Permitting decisions - Refusal

We have decided to refuse the variation application for Ellesmere Port Wastewater Treatment Works Combustion Plant operated by United Utilities Water Limited.

The proposed facility location is Ellesmere Port Wastewater Treatment Works Combustion Plant, Little Stanney, Nr. Chester, Cheshire, CH4 5JA.

Figure 3 – Mesophilic Digester Tank Failure

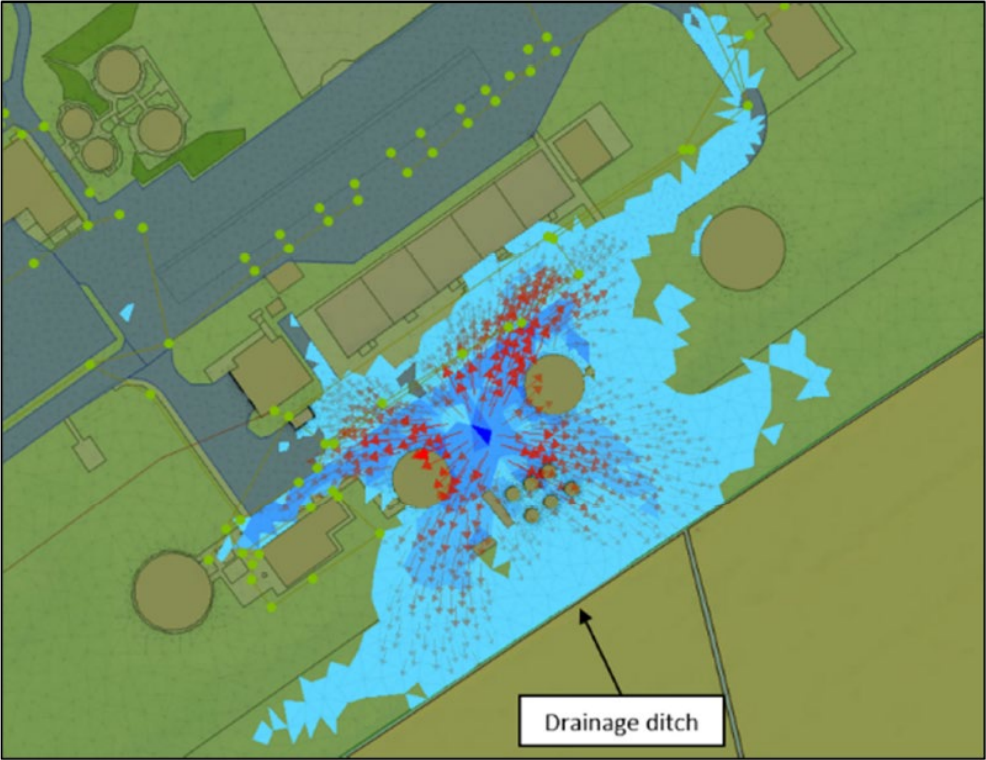
The modelling illustrates that in the event of a catastrophic failure of these tanks, with the current infrastructure, waste could spread to permeable ground, breach the permit boundary, breach the wider site boundary, and potentially impact the WwTW and identified receptors, including Mill Brook. Figures 3, 4, 5 and 6 below are taken from the report.

Figure 6 – Thickened SAS Tank Failure

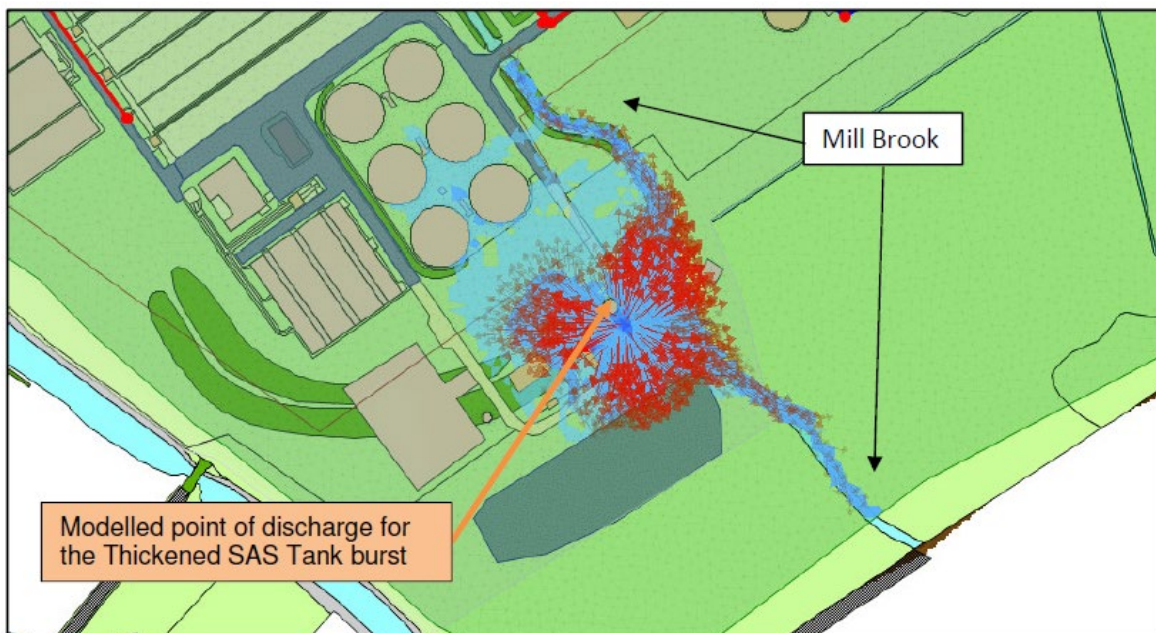
- Some assets were allocated a risk of harm score of 0 as the Applicant determined that the source-pathway-receptor linkage had been broken. This included the thickened SAS tank, which was allocated a score of 0 for leak likelihood based on mitigating factors being in place to reduce the leak likelihood. No explanation of mitigating factors in place was provided apart from the indication in the score allocation. This score directly conflicted with the spill modelling report which showed that a tank failure would enter Mill Brook and migrate across permeable ground.

Figure 7 – Proposed mitigation measures for the mesophilic digesters and post digestion tanks

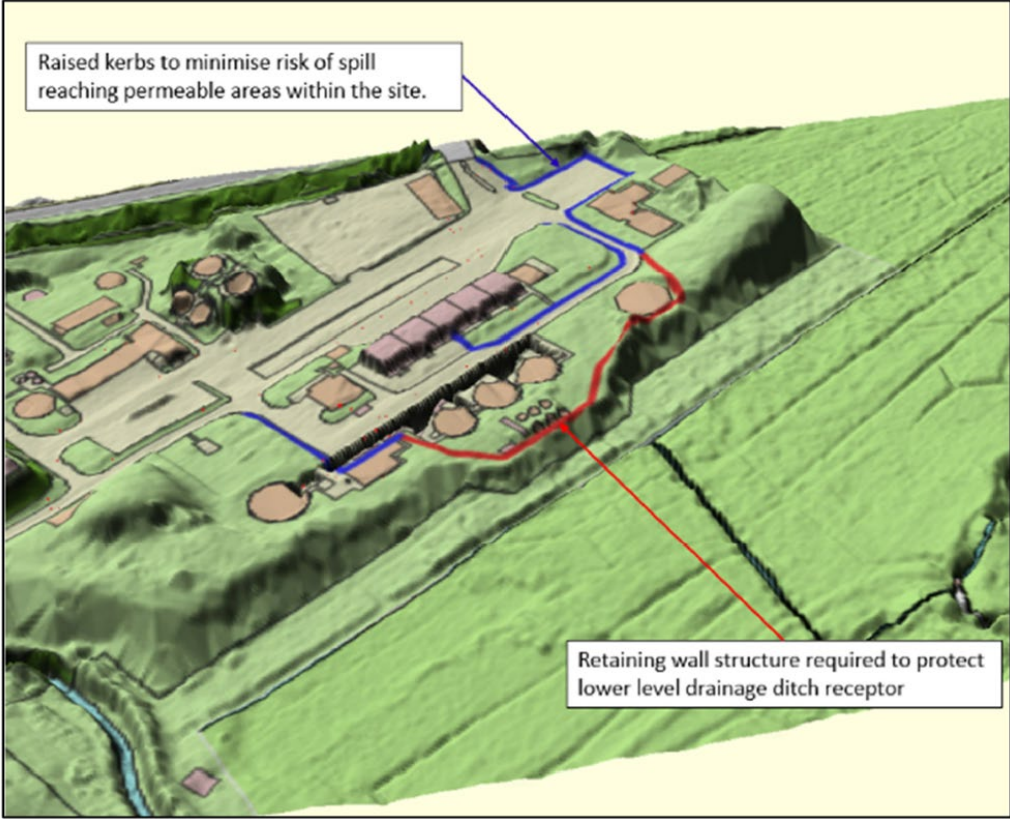
As an example of this, the Applicant identified solutions to mitigate a tank failure from the mesophilic digesters and post digestion tanks. The Applicant’s supporting information showed that in the event of a failure sludges would flow back into the site across permeable ground, down the embankment on the southern edge of the sludge treatment centre and into the drainage ditch receptor. The applicant proposed raised concrete kerbing to a depth of 325mm advising that this is “to contain the spillage within the impermeable areas wherever possible” It also identified a precast concrete 1m high retaining wall to be constructed along the edge of the embankment to minimise the risk of contamination to the drainage ditch stating that the wall height had not been confirmed due to the existing ground profile.

On assessment of this solution the “*raised kerbs to minimise risk of spill reaching permeable areas within the site*” (identified as a blue line on figure 7 above), would have contained a spill within areas identified in the site surfacing as soft landscaping / made ground, and mixed surfacing e.g. gravel, concrete paving or soft landscaping” which have not been identified as impermeable surfaces. No calculations were provided to demonstrate that the solutions proposed would allow for the containment of 110% of the largest tank, or 25% of the total volume of the tanks, and no spill modelling had been undertaken to demonstrate the impacts of a tank failure following the implementation of the site improvements identified.

The proposals lacked the detail required for us to adequately assess improvements, they did not explain or provide information on existing containment in place, they did not address failures in tanks not included in the spill modelling, and they were not run through the spill modelling to show the impact following implementation or installation of the solutions/improvements.
